Town of Hilton Head Island
Design Review Board Meeting
Tuesday, March 22, 2022 – 1:15 p.m.
AGENDA

i. Chimney Cove Multifamily Development, DRB-000635-2022

i. Belly Goat Burgers, DRB-000636-2022

DESIGN TEAM/DRB COMMENT SHEET

Chimney Cove

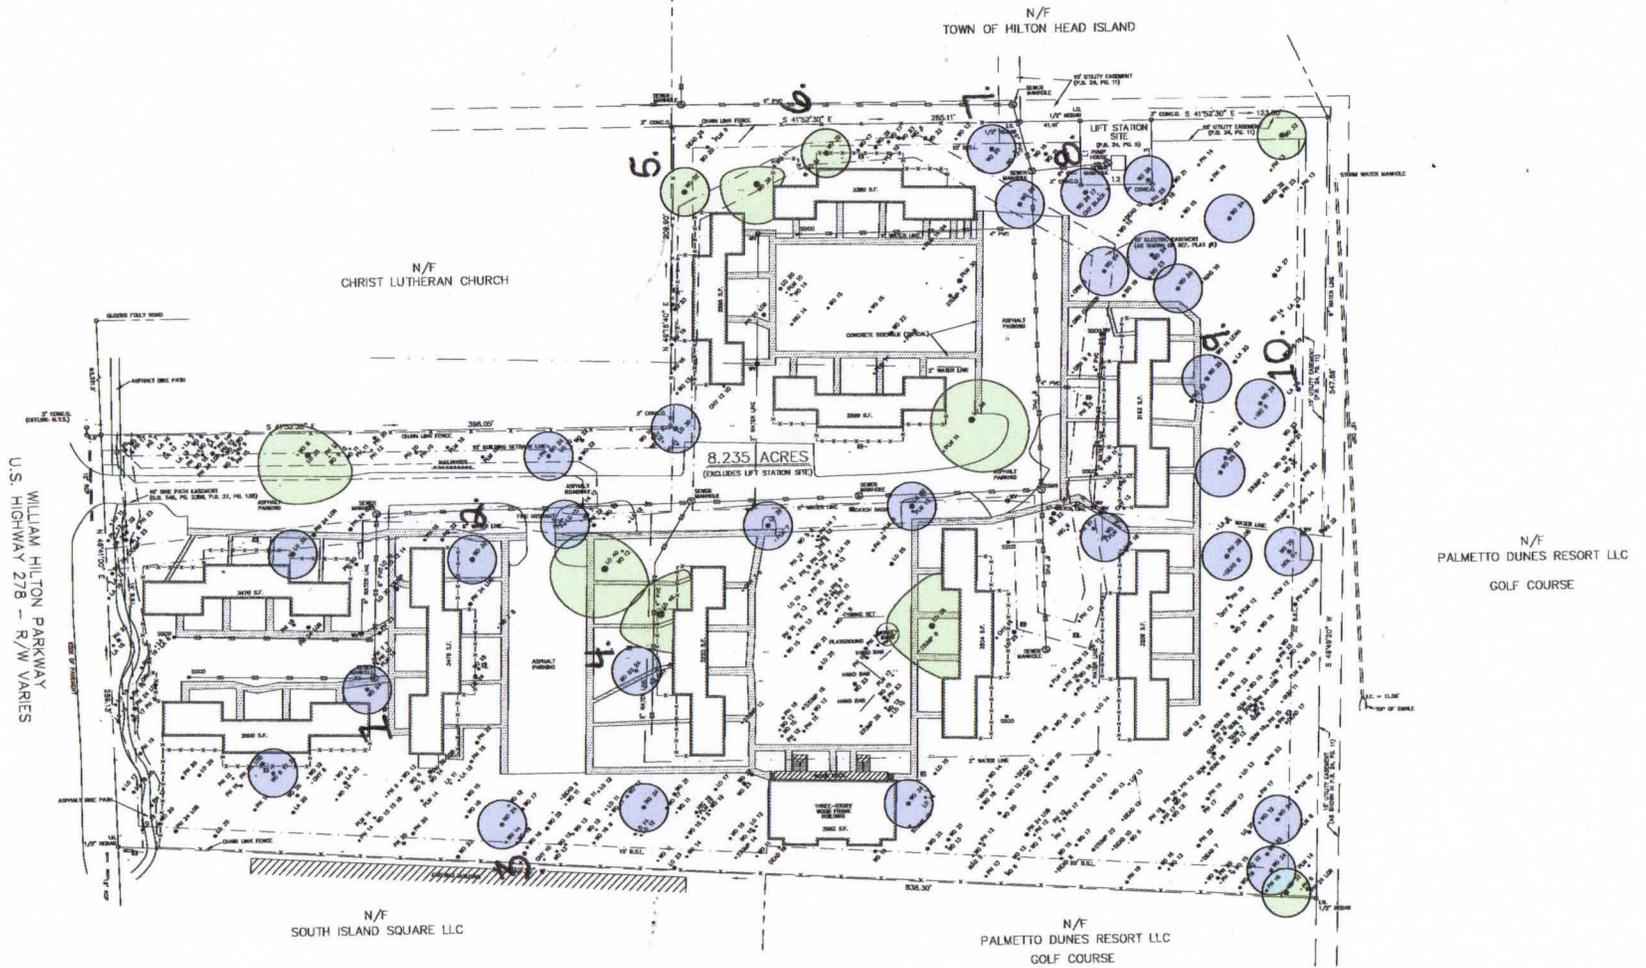
1. Unit 37, 24" Water Oak has girdling roots, evident trunk decay, crown dieback and existing mistletoe.
2. In Front of unit 32, 30" Laurel Oak that has wood borer activity and existing deadwood that needs to be **removed**. Has existing mistletoe due to crown stress, but structurally sound.

3. Left front of unit 29 near dumpster in natural buffer invasive vine damage and die back **Remove**.
4. In Front of unit 27, 20"x24" Laurel Oak needs to be **removed**.

5. Rear unit 1 there is a 32" Laurel Oak that needs to be **removed** due to insufficient canopy to trunk ratio, existing previous storm damage.
6. Rear of unit 10 there is a 32" Water Oak stub that needs to be **removed**.

7. Right rear corner of unit 12, 28" Water Oak in natural buffer prune invasive vine growth.
8. Lift station 8 Laurel Oak 28"x17" **remove** the 17" leader due to decay.

9. Rear of property at sidewalk 25" Laurel Oak needs resistograph testing. Existing trunk decay and borers.
10. Rear of property at natural buffer 26" Water Oak stub dead, needs **removal**.
